Addendum No. 3
E19: Seguin Road to Nacogdoches Road
SAWS Project No. 15-4506
Solicitation No. CO-00104-DW

**SAN ANTONIO WATER SYSTEM
E19: SEGUIN ROAD TO NACOGDOCHES ROAD
SAWS PROJECT NO. 15-4506
SOLICITATION NO. CO-00104-DW
ADDENDUM NO. 3**

December 6, 2016

The purpose of this addendum is to issue a revision to the Contract Documents, plans and specifications for E19: Seguin Road to Nacogdoches Road (SAWS Job No. 15-4506).

DATE:	SAWS PROJECT NO.	SHEET NO.
NOVEMBER 2016	15-4506	G5
DESIGN: RWR	FNI PROJECT NO.	
DRAWN: DDH	KMH16157	
CHECKED: DTB

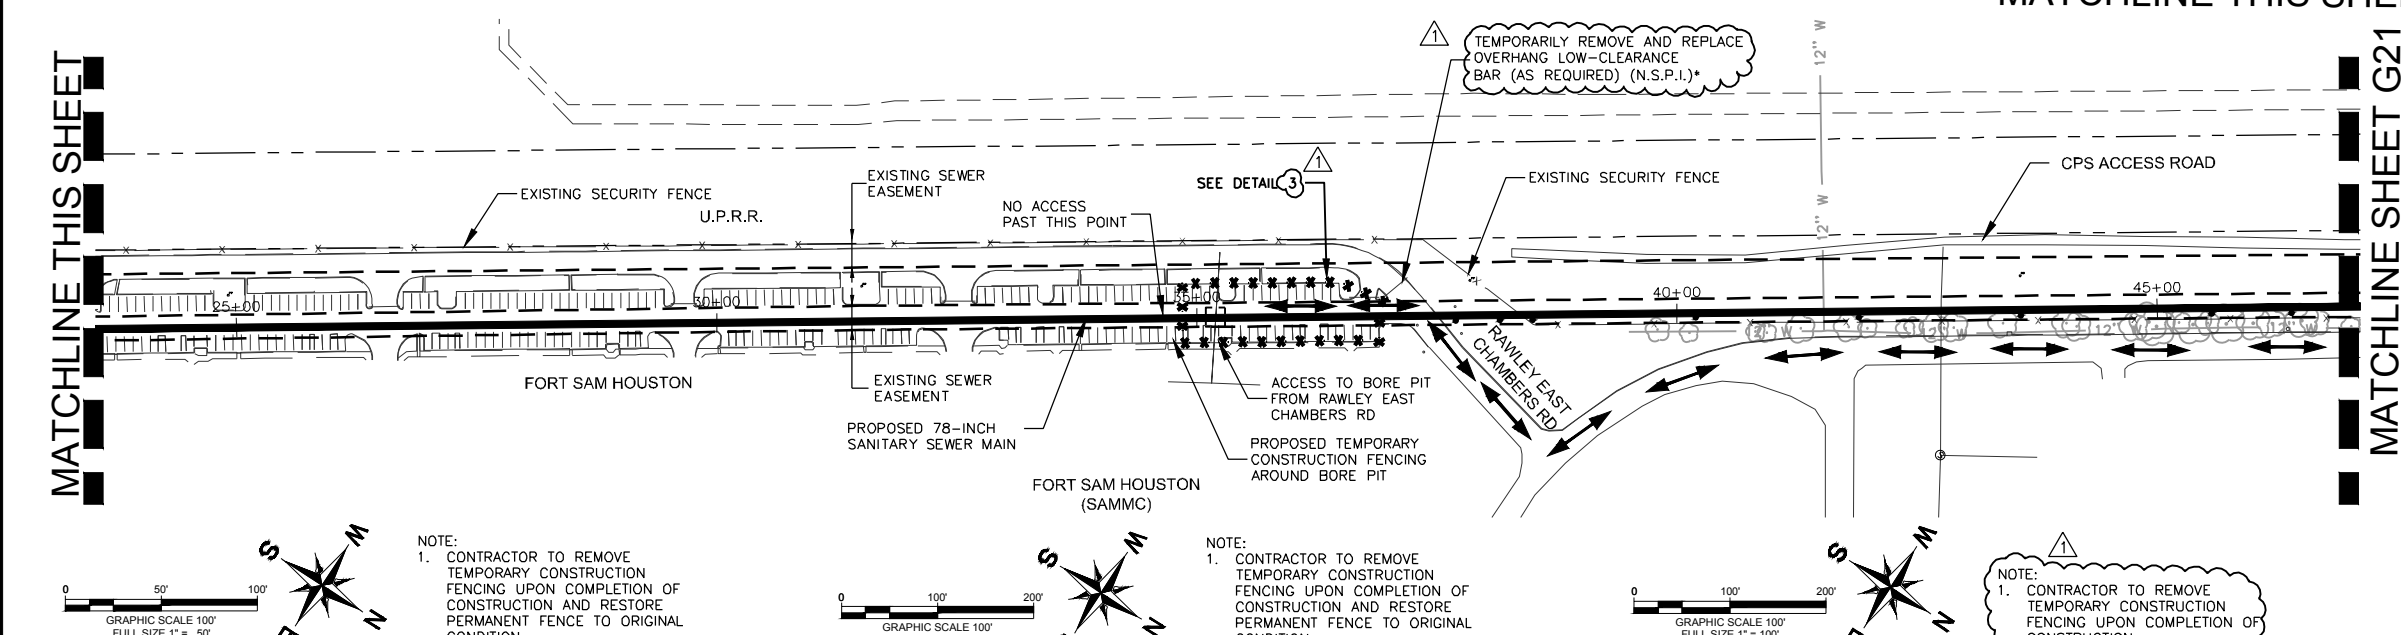
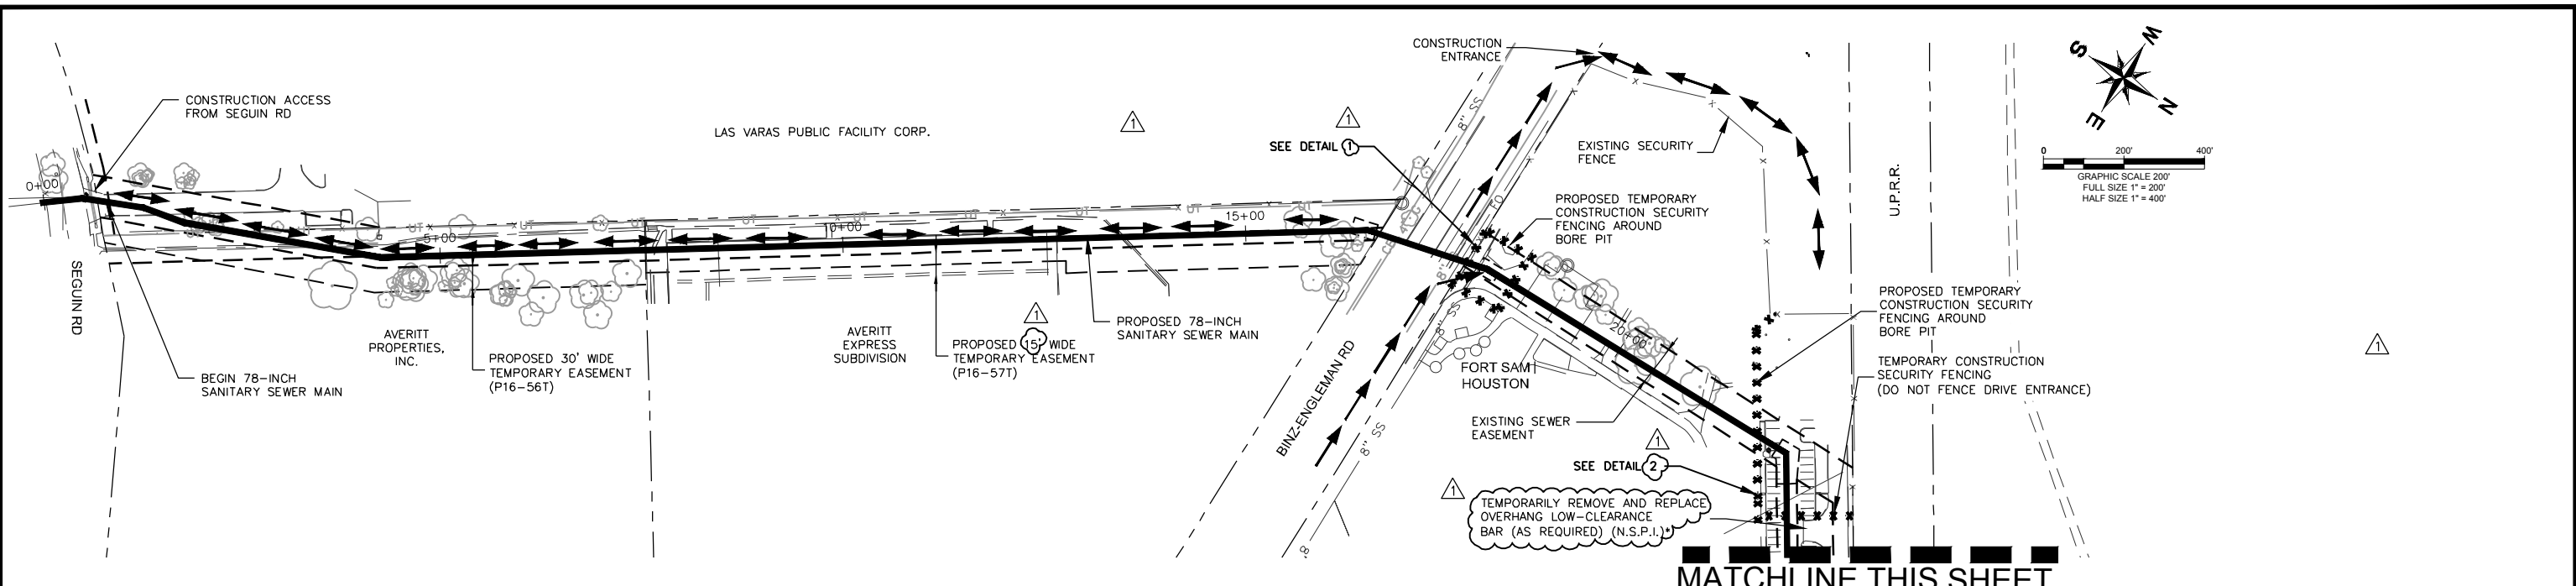
Response: *Two line items have been created for demobilization/remobilization, one for use in Microtunneling applications (line item #95), and the other for use in open cut applications (line item #94). See revised bid proposal and sheet G5, attached to this addendum.*

FORT SAM HOUSTON CLOSURE COUPLING TEE BASE FIBERGLASS MANHOLE DETAIL

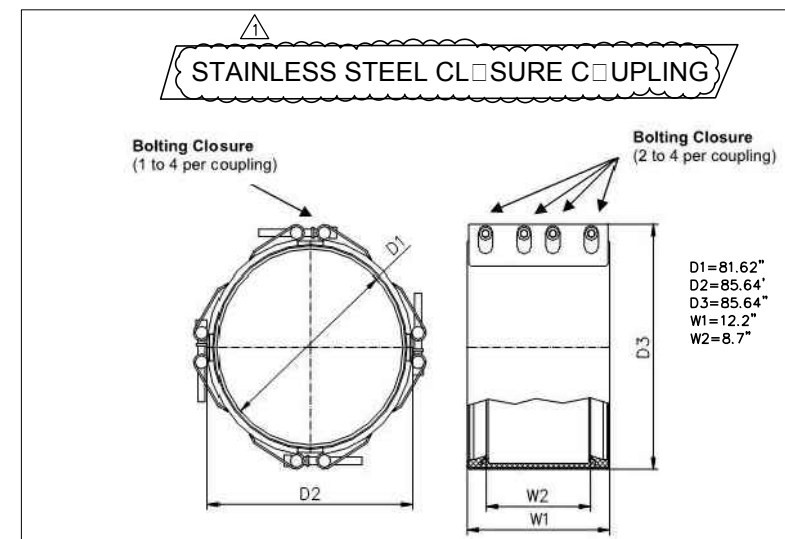
- g. REMOVE – Sheet C10, C11, C12, C13, C14, C15, C16, C17, and C19 78-inch Sanitary Sewer Plan & Profile, REPLACE with revised attached Sheet C10, C11, C12, C13, C14, C15, C16, C17, and C19.
- h. REMOVE – Sheet C33 78-inch Sanitary Sewer Plan & Profile Sta. 125+00 to 129+00, REPLACE with revised attached Sheet C33.
- i. REMOVE – Sheet C51, C52, C53, C54, C55, and C58 8-inch Waterline Plan, REPLACE with revised Sheet C51, C52, C53, C54, C55, and C58.
- j. REMOVE – Sheet C66 16-inch Waterline Plan & Profile Sta. 12+80 to 16+80, REPLACE with revised attached Sheet C66.
- k. REMOVE – Sheet C69 General Details (Sheet 2 of 5), REPLACE with revised attached Sheet C69.
- l. REMOVE – Sheet C76 Sewer Details (Sheet 4 of 4), REPLACE with revised attached Sheet C76.
